TE Connectivity

Product Change Notification: PCN-25-255802

CPC accessories (cable clamps, protective caps and extenders)

The material used in the CPC portfolio is being transitioned from Nylon (PA) to Polybutylene Terephthalate (PBT) resin. The new PBT material meets all current functional and performance requirements of the component and is fully qualified for the intended application. Small modification were added to some components not affecting performance (see attachments).

NEW SIZE 23 CABLE CLAMP FEATURES

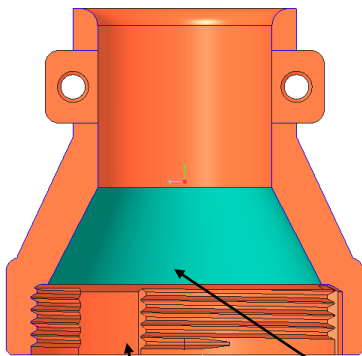
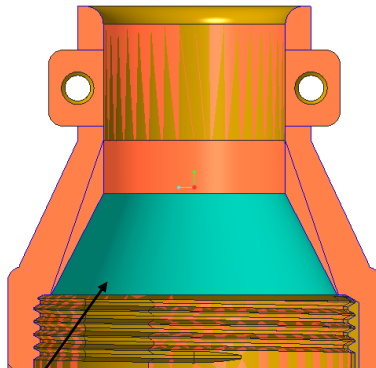
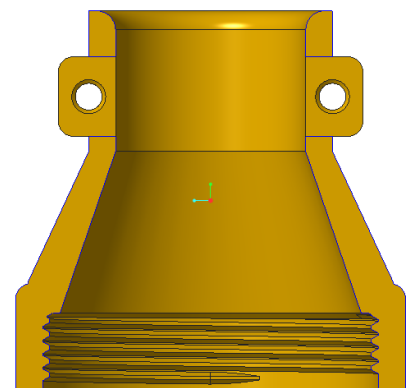
Added thread cutouts (3 places)
for collapsible core.

Changed angle run out
distance to allow for more
robust collapsible core.

Affected Items:
206138-8
1-206138-0

NEW SIZE 23 CABLE CLAMP FEATURES

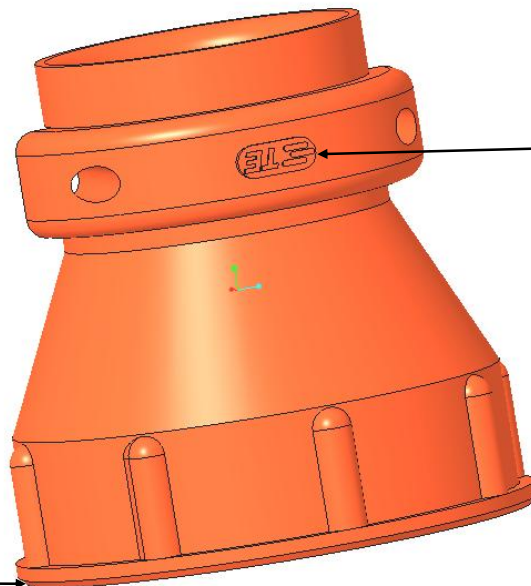
Logo change: TE

Chamfer added on this area

Affected Items:
206138-8
1-206138-0

NEW SIZE 23 CABLE CLAMP FEATURES

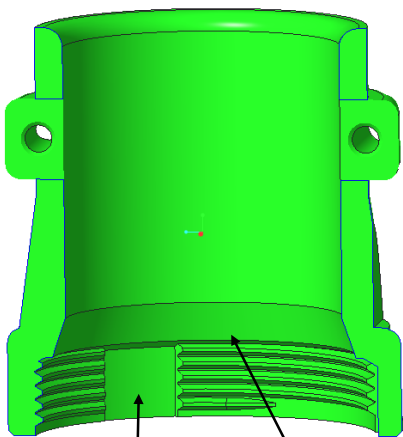
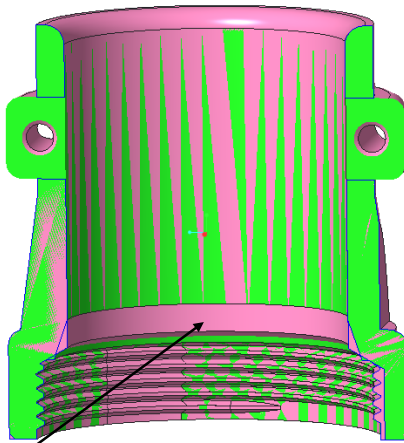
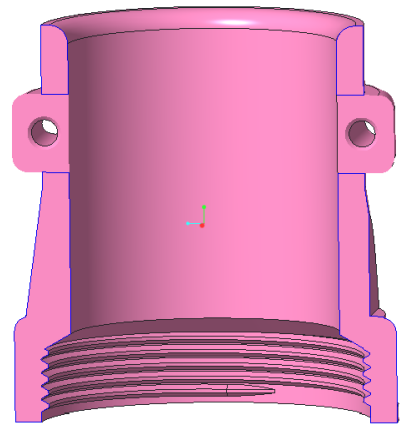
Added thread cutouts (3 places)
for collapsible core.

Changed angle run out
distance to allow us to use
the same collapsible core
for multiple part numbers

Affected items:
827770-2
2267474-1
2267474-2
206512-5
206512-6

NEW SIZE 23 CABLE CLAMP FEATURES

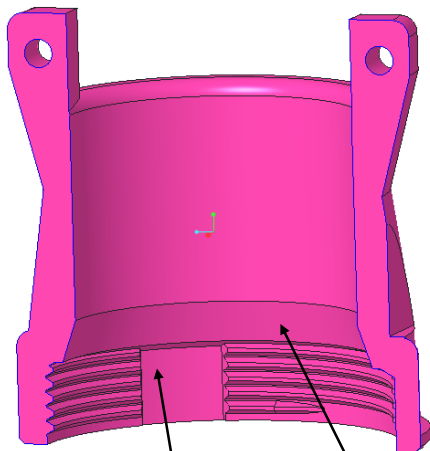
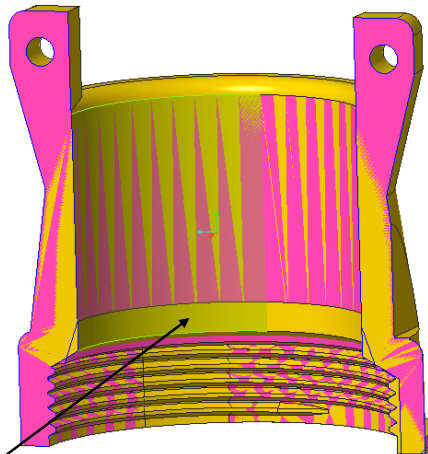
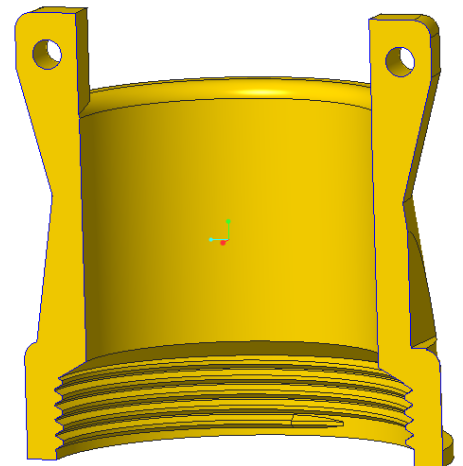
Added thread cutouts (3 places)
for collapsible core.

Changed angle run out
distance.

Affected Items:
207774-3
207774-4

NEW BACKSHELL EXTENDER SIZE 23 FEATURES

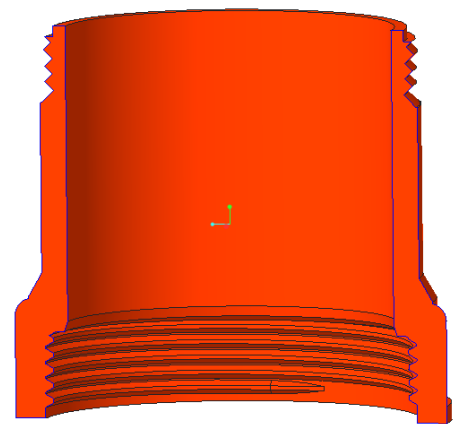
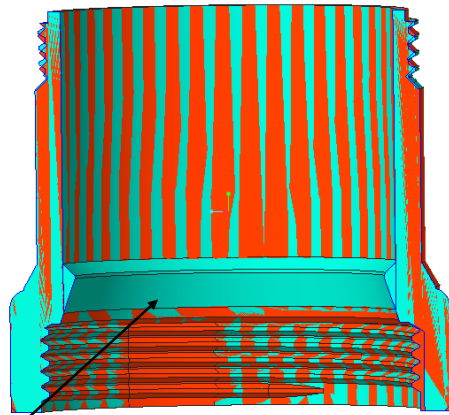
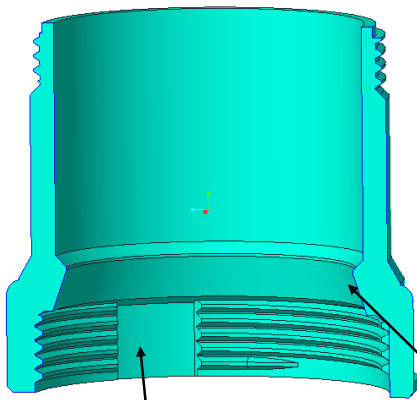
Added thread cutouts (3 places)
for collapsible core.

Changed angle run out
distance.

Affected items:
207052-3
207052-1
207052-2

NEW BACKSHELL EXTENDER SIZE 23 FEATURES

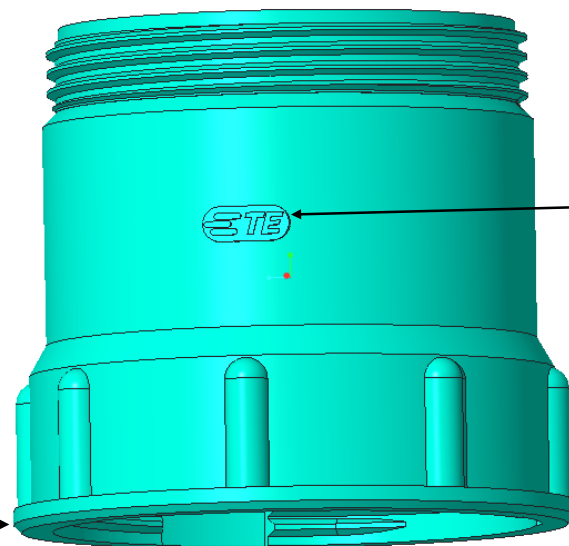
Chamfer added on this area

Logo change: TE

NEW CABLE CLAMP SIZE 17 FEATURES

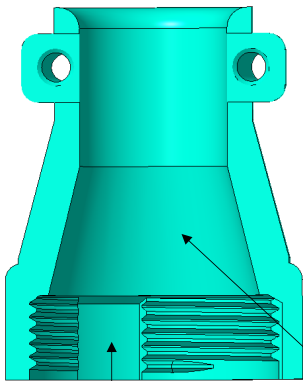
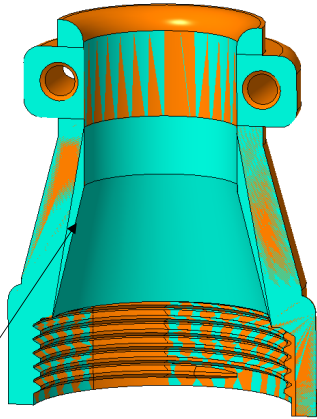
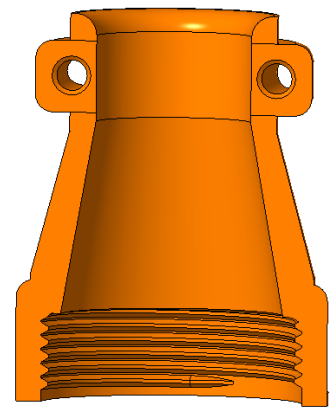
Added thread cutouts (3 places)
for collapsible core.

Changed angle run out
distance.

Affected Items:
206070-8
1-206070-0
1-206070-1

NEW CABLE CLAMP SIZE 17 FEATURES

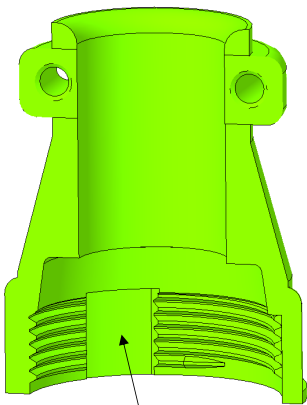
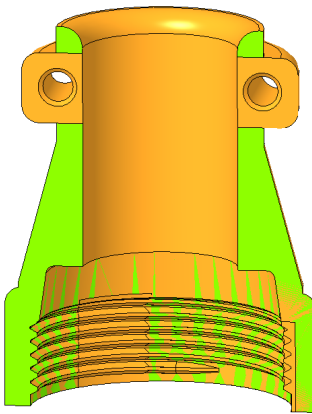
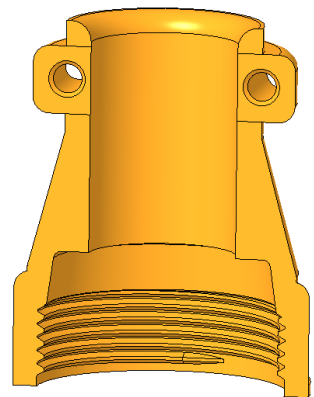
Added thread cutouts (3 places)
for collapsible core.

Affected Items:
213904-3
213904-4

NEW CABLE CLAMP SIZE 17 FEATURES

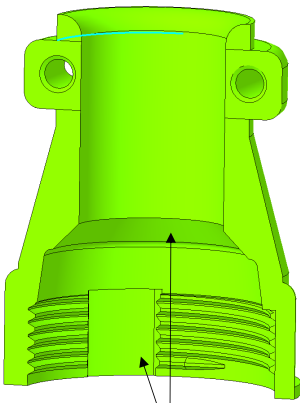
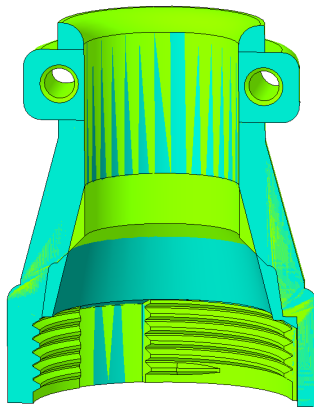
NEW:
206070-8
1-206070-0

Add chamfer and thread cutouts (3 places) for collapsible core.

NEW CABLE CLAMP SIZE 17 FEATURES

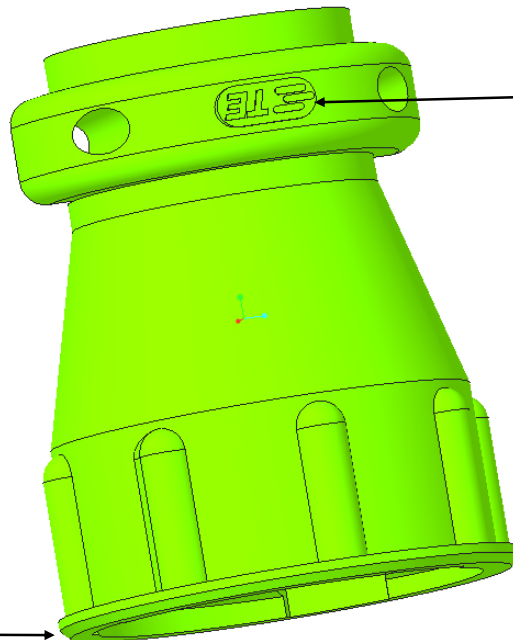
206070-8

1-206070-0

Logo change: TE

Chamfer added on this area

NEW SIZE 13 CABLE CLAMP FEATURES

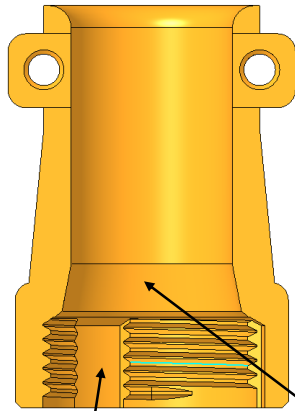
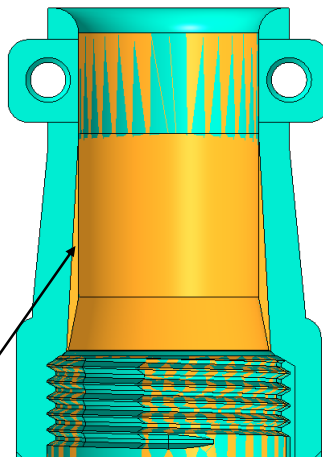
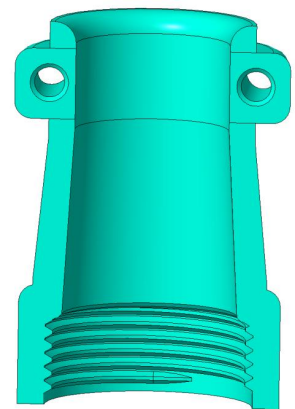
Added thread cutouts (3 places)
for collapsible core.

Changed angle run out
distance.

Affected items:
206966-7
206966-9
